**AGENDA PACKET**

**APRIL 16, 2019 MEETING**

**TOWN OF LEWISBORO**  
**Westchester County, New York**

**AGENDA**

**SITE UTILITY DRAINAGE, SOIL & EROSION CONTROL PLAN**

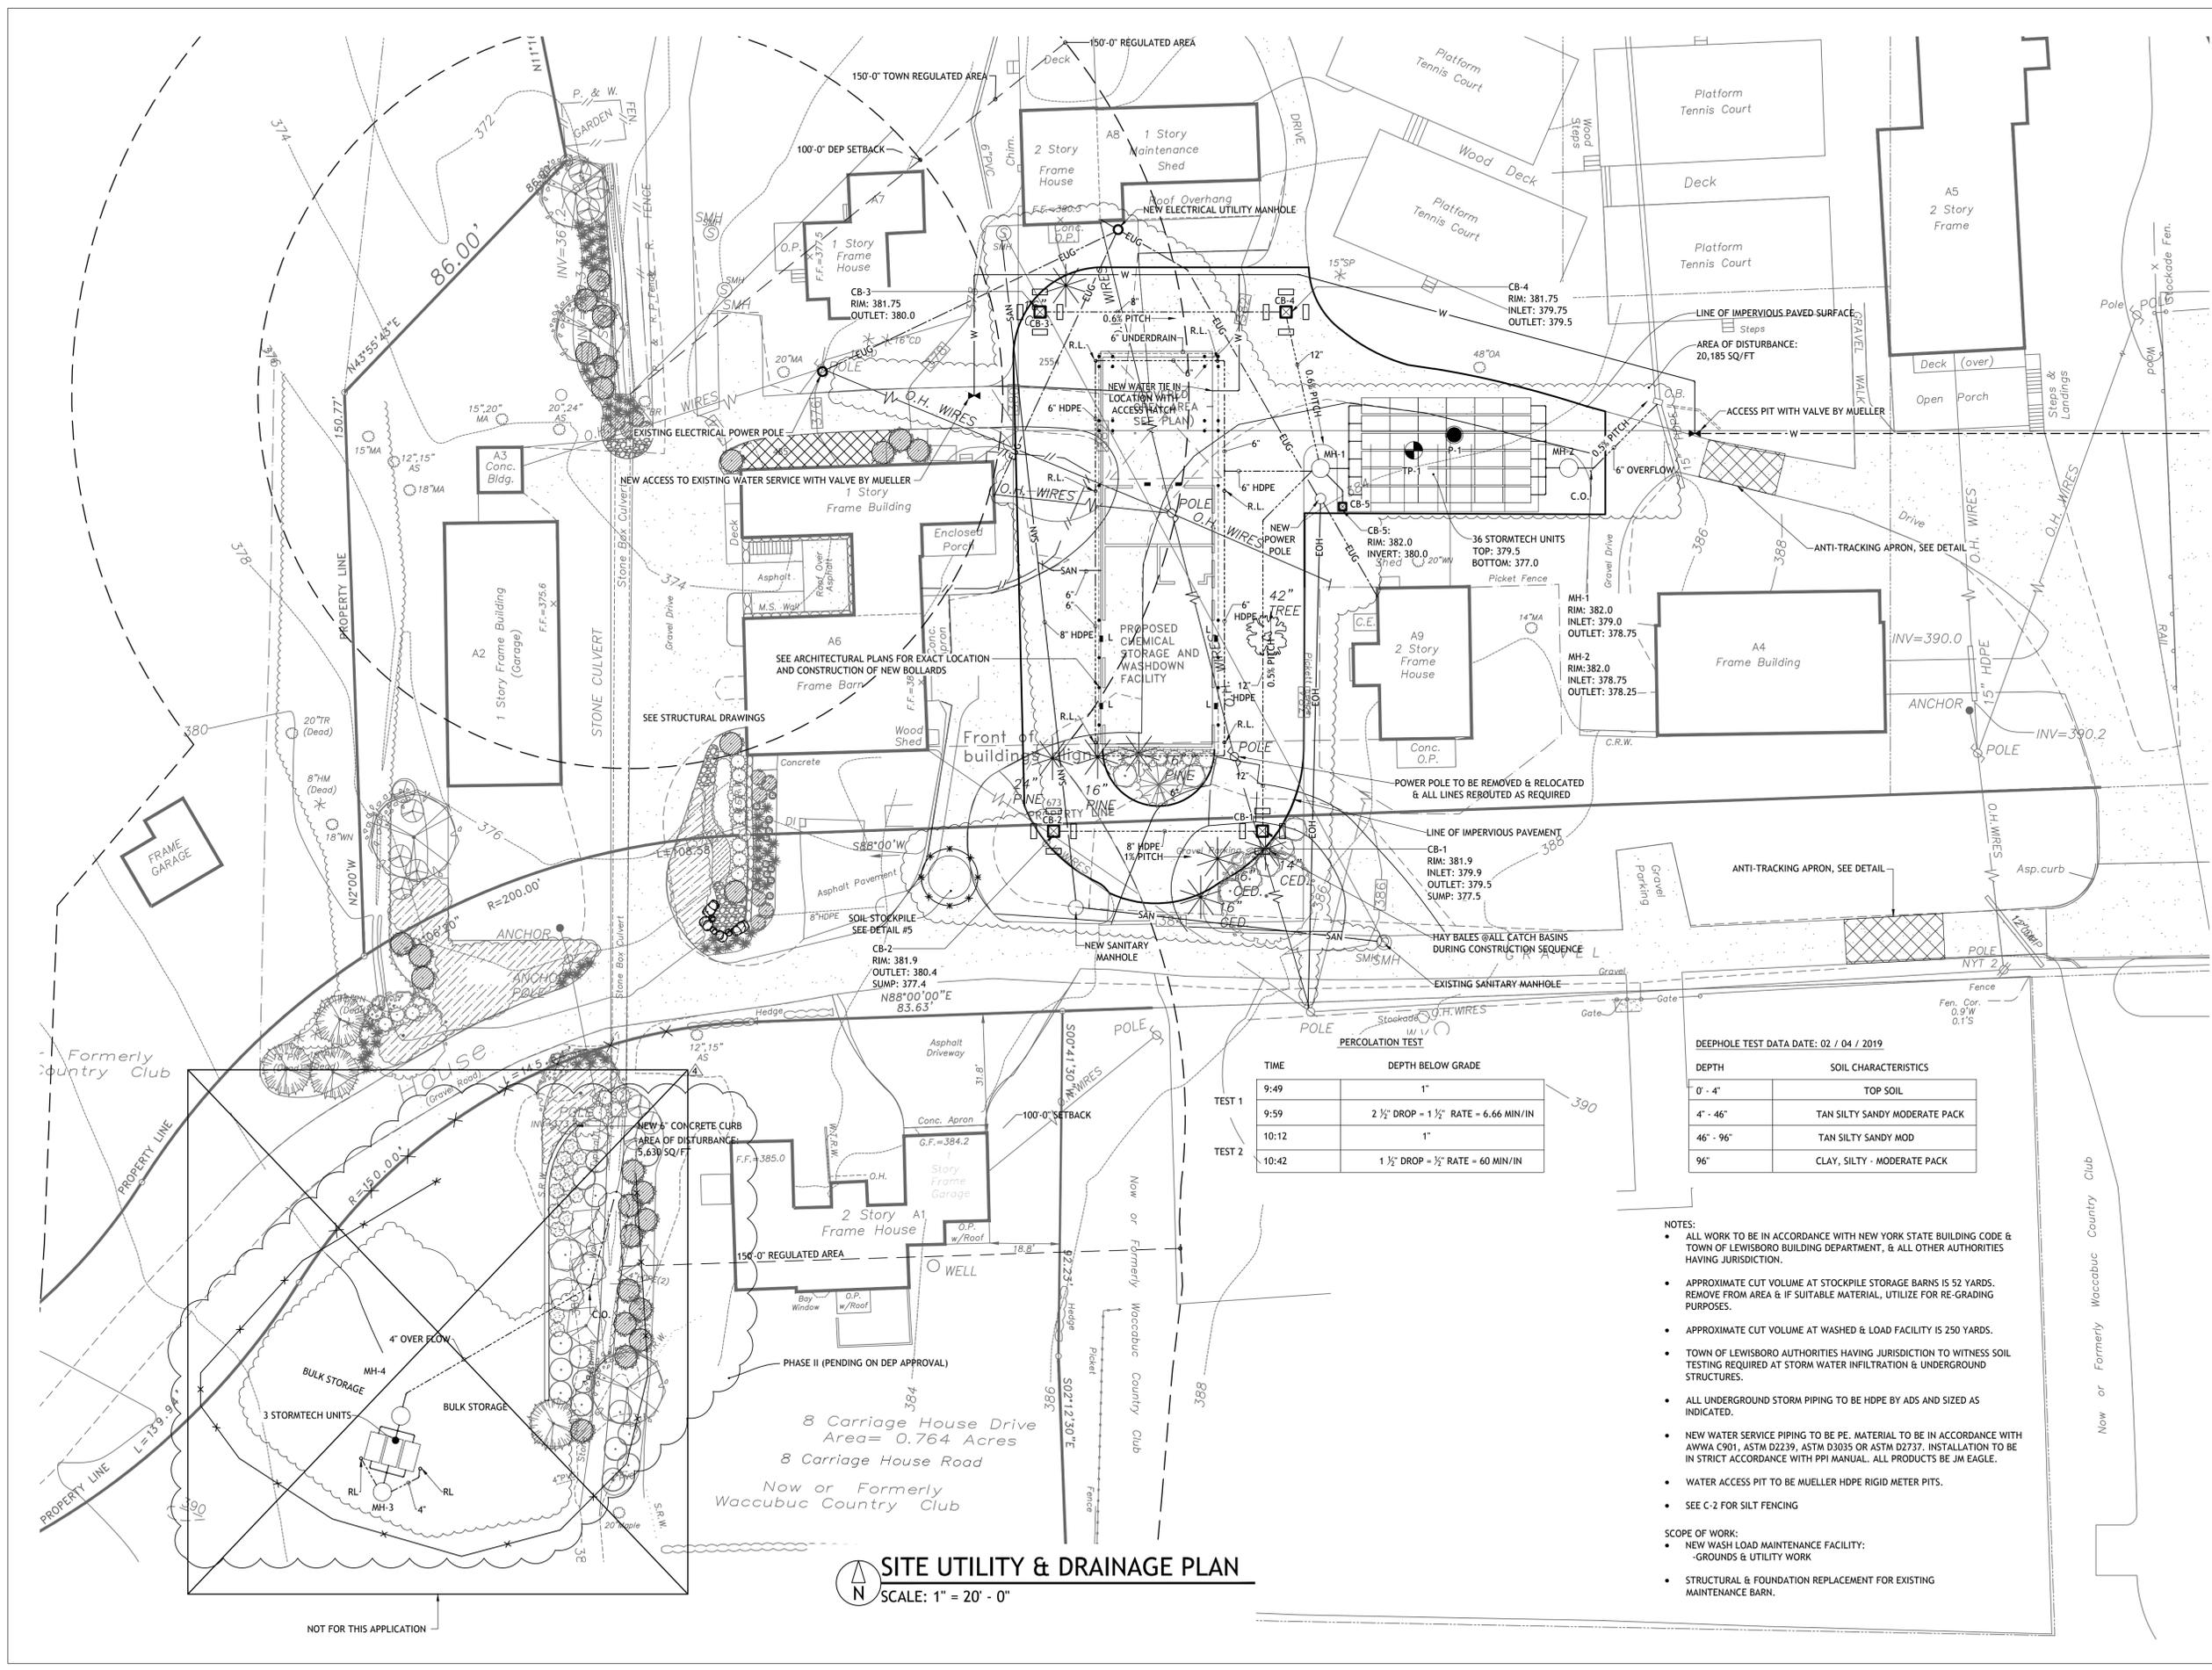
1. As previously requested, the Bulk Storage sheds are no longer proposed and, as such, these improvements along with associated stormwater mitigation and any references to Phase II shall be removed from Drawings C-1 and C-2.
2. As previously requested, the applicant has provided a draft Notice of Intent (NOI) for review. We offer the following comment:
  - Include the Federal Tax ID on Page 1.
  - Include the Tax Map Numbers in the project site information.
  - Question #2 should identify a "Redevelopment with increase in impervious area".
  - Question #12 should be answered "Yes".
  - Question #13 should be answered "No".
  - Question #22 should be answered "No".
  - Skip Questions #23 and #27 - #39.
  - Question #42 should be answered "Yes".
  - Question #43 should be answered "Yes".

6. The limit of disturbance shown on Drawing C-1 shall be adjusted to include all improvement areas and to exclude those that are no longer part of the proposed scope of work; the disturbance limit line shall be updated accordingly.

9. As requested by the Planning Board, the note on Sheet C-2 referring to the replacement of the foundation and floor of the existing barn shall be removed.

1. See attached drawing sets; Base Map Survey, C-1, C-2, C-3, C-4, L1, L2, AS1.0, A1.1, A1.2, A1.3, A1.4, DWG-SPL, 5795/7, 5982.6SP, 4480, 4904/1.
2. Bulk Storage Sheds have been removed from the drawings.
3. Variances added to Zoning Table on AS1.0.
4. Variance related to Bulk Storage no longer apply.
5. The applicant is prepared to discuss the outcome of the NYCDEP consultation about the bulk storage facility. However, the bulk storage facility is no longer part of this application, and has been removed from the plans, The NYC DEP consultation is no longer relevant.

6. Drawing L1 and L2 have been revised to reflect the current site layout (bulk storage removed).
7. Draft NOI is included in this submission. An MS-4 is not required because we are not discharging storm water runoff to a Lewisboro storm system.

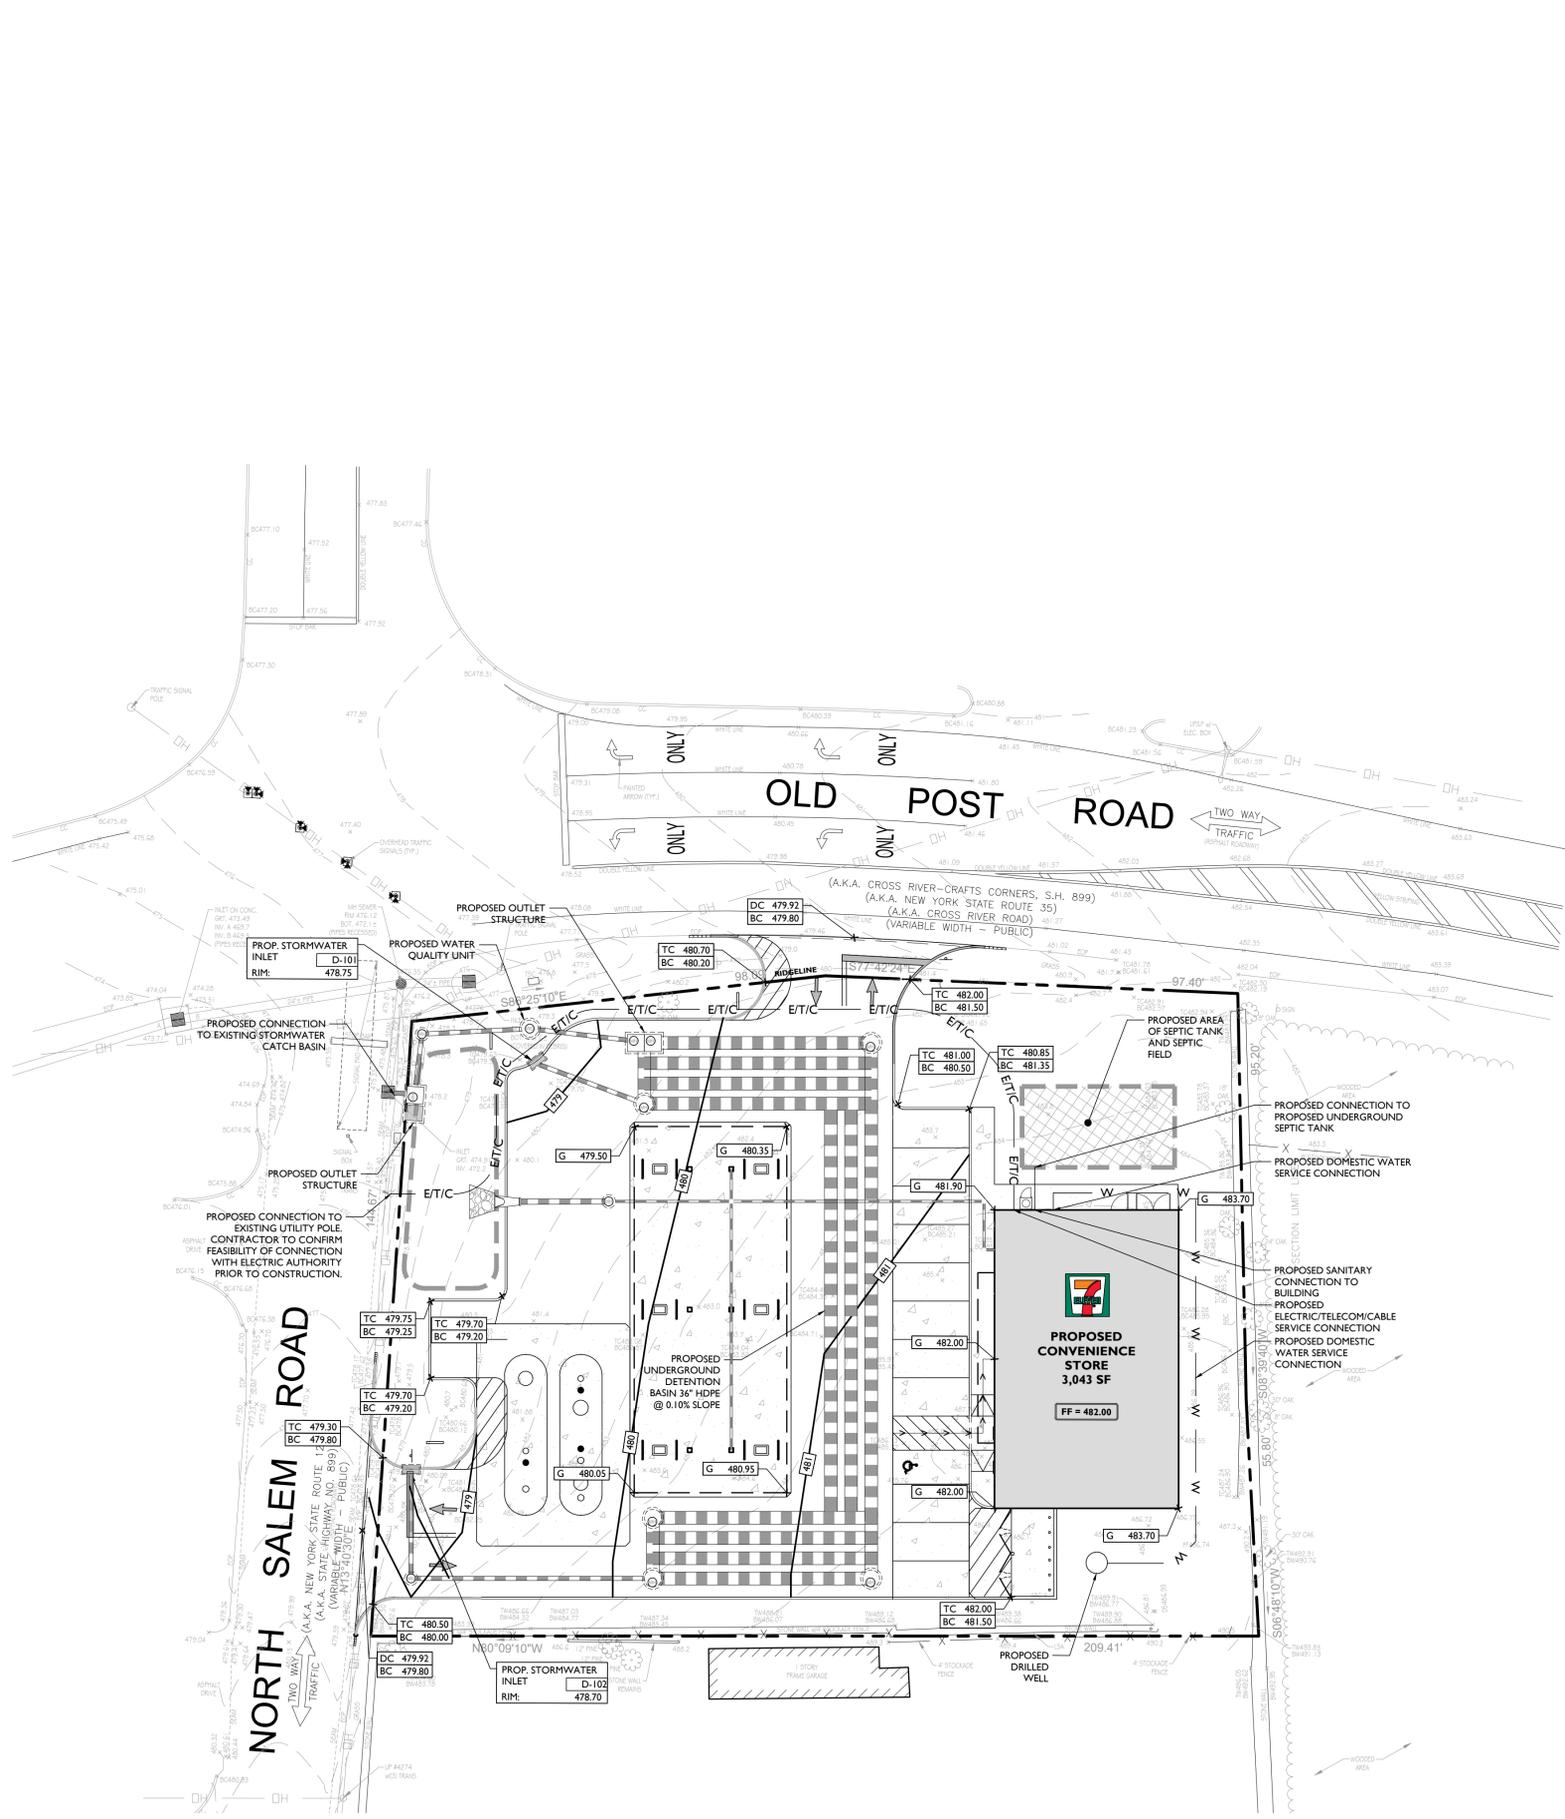
8. Notes on Sheet C-3 mistakenly identify the Zoning Board of Appeals as the Board having jurisdiction over the Special Use Permit; further, while we defer to the Building Inspector, we assume the convenience store would be considered an accessory retail use; please revise the notes on Sheet C-3 accordingly.
